SP2024-033: PD Site Plan for the Terraces Amenity Center

- I.1 This is a request for the approval of a Site Plan for an amenity center on a 0.52-acre parcel of land identified as Lot 18, Block A, Terraces, Phase 1, City of Rockwall, Rockwall County, Texas, zoned Planned Development District 93 (PD-93) for Single-Family 10 (SF-10) District land uses, addressed as 1845 Terraces Boulevard.

- I.4 This project is subject to all requirements stipulated by the Unified Development Code (UDC) and Planned Development District 93 (PD-93).
- M.5 Photometric Plan:

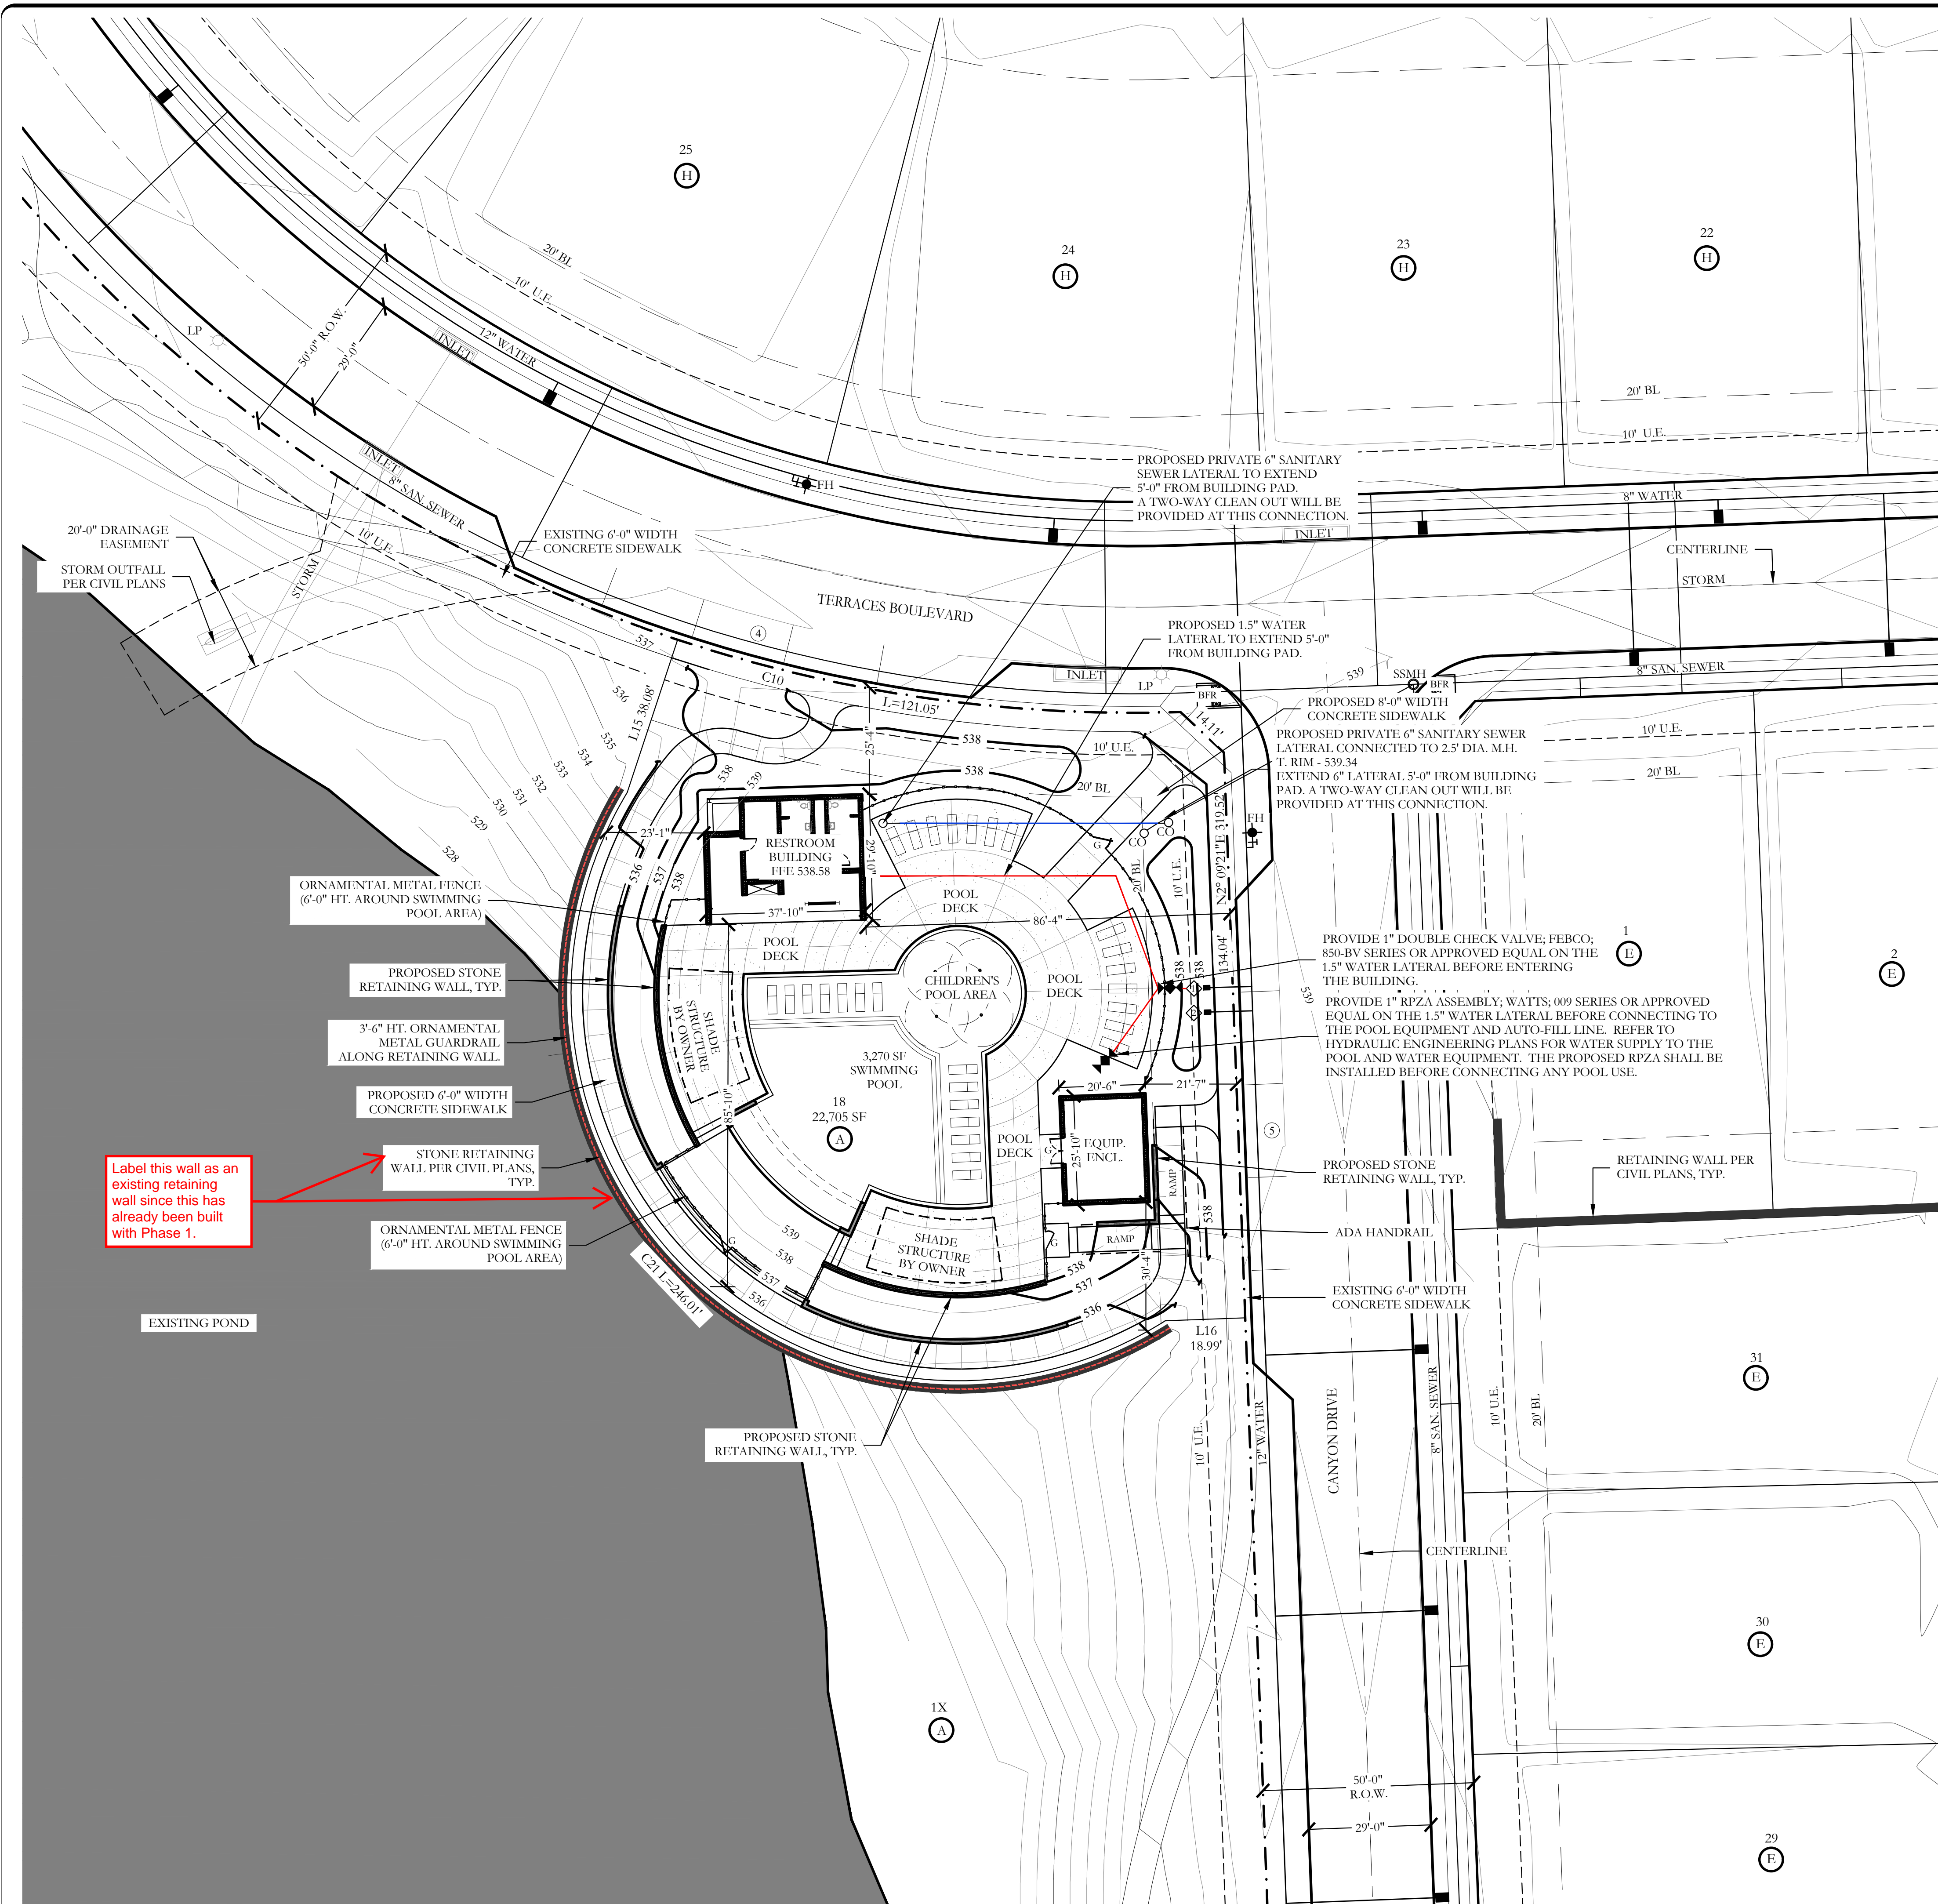
- Retaining walls 3' and over must be engineered.
- All retaining walls (18" or taller) must be rock, stone, or stone face. No smooth concrete walls.
- All utilities must be underground.
- Additional comments may be provided at time of Engineering Plan Review.

- No trees to be with 10' of any public water, sewer or storm line that is 10" in diameter or larger.
- No trees to be with 5' of any public water, sewer, or storm line that is less than 10"
